REVIEWED ONLY AS TO GENERAL COMPLIANCE WITH THE INTENT OF THE GRADING AND SERVICING DRAWINGS. THE ENGINEER DOES NOT WARRANT THAT THE INFORMATION CONTAINED ON THIS PLAN IS EITHER ACCURATE OR CORRECT. SOLE RESPONSIBILITY FOR CORRECT DESIGN, DETAILS AND DIMENSIONS WILL REMAIN WITH THE PARTY SUBMITTING THE DRAWING

ROUNDEL HOMES INC. (PH-2)

LOT No. 75

CURRENT DRIVE

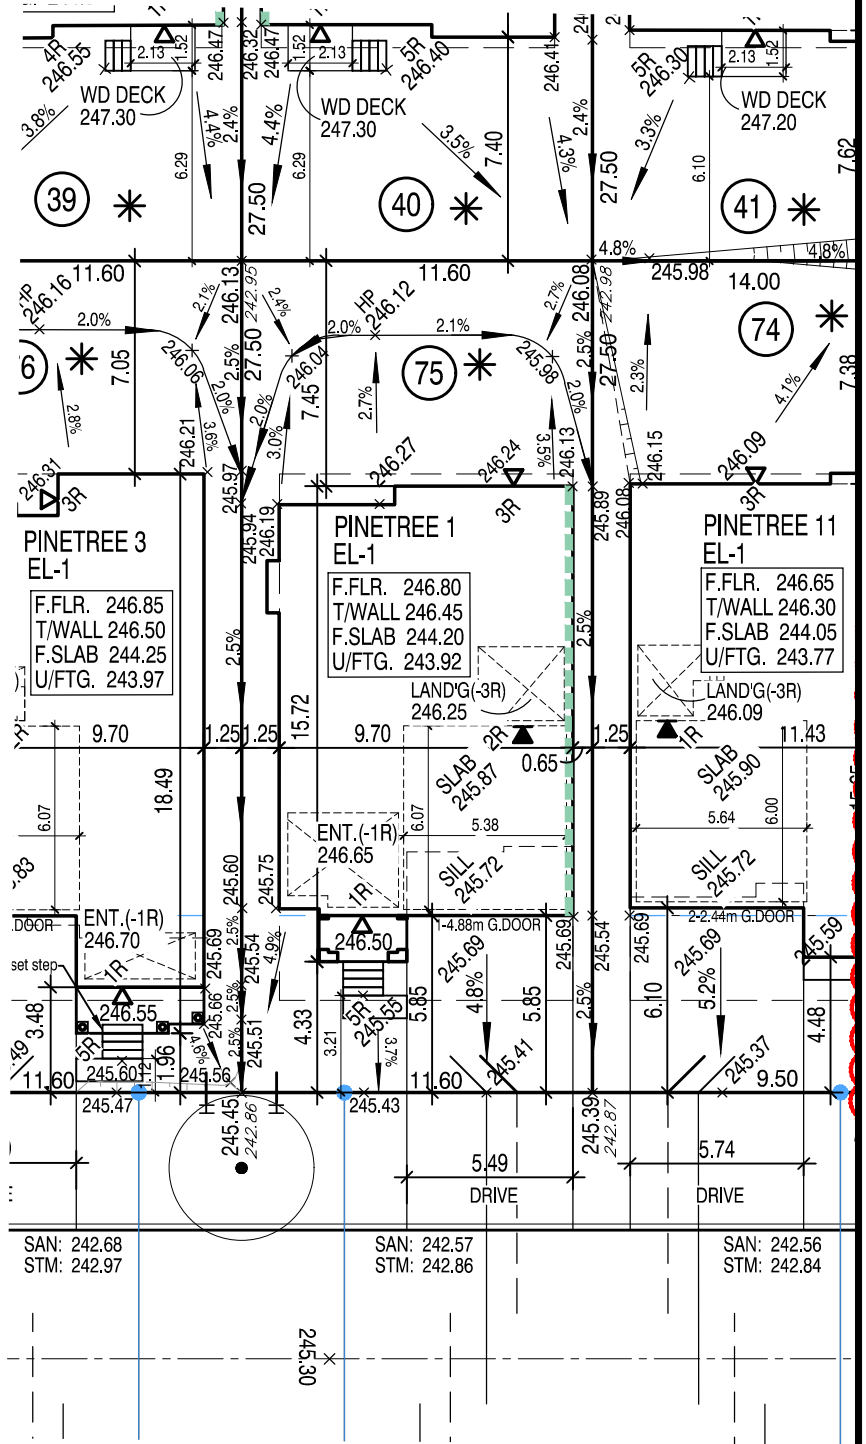
No unprotected openings permitted within 1.2 metres of the lot line as per 9.10.14 of the Ontario Building Code.

45 MINUTE RATED WALL WITH SIDE YARD < 1.2m
